Representation Regarding Planning Application for 18 Fordington Road **HGY/2026/0507**

We, Mr and Mrs Marchetti, the owners of 20 Fordington Road, wish to submit the following observations regarding the proposed two-storey side extension at 18 Fordington Road.

The applicants' agents reference the 45-degree splay test in their documentation (specifically second-floor plan on sheet number B354274-01-3100 rev A, and proposed front elevation on sheet number B354274-01-3200 rev A). See excerpts below.

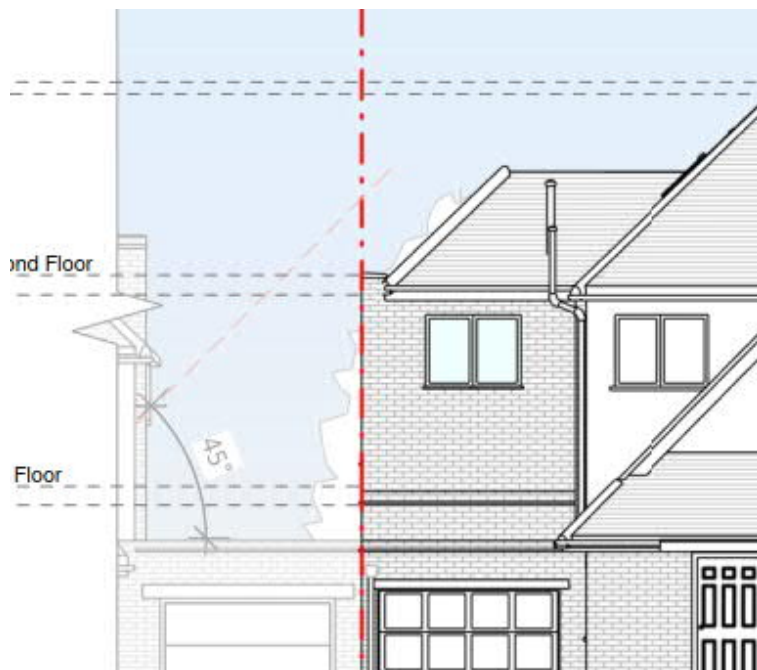
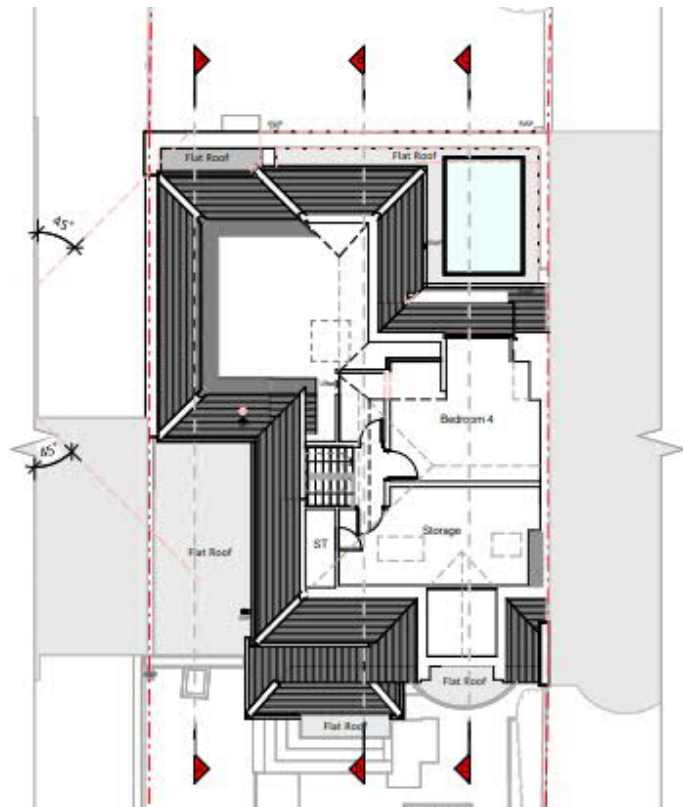
While nr 18 agents cite the 45-degree test, our side elevation features windows perpendicular to the proposed extension. However, for windows at the side, the correct splay angle in relation to neighboring windows perpendicular to the proposed extension is typically considered to be the 25-degree splay (which is more stringent than the 45 deg shown).

The existing windows at our property (20 Fordington Road) have not been surveyed or clearly shown on the proposed drawings nor take into account the approved plans (which are clearly known to nr 18's agent as they refer to them).

- Therefore, it is unclear what the 45-degree splay cited by the applicants and shown in the aforementioned drawings refers to (the angle drawn from the centre of the perpendicular windows should be in any event 25 degrees, as previously noted).

Recommendation: We request that Haringey Council take our concerns into account and ask the applicants to commission a detailed BRE Daylight & Sunlight Report to properly evaluate the impact on natural light, confirming compliance with the 25-degree and 45-degree tests where applicable.
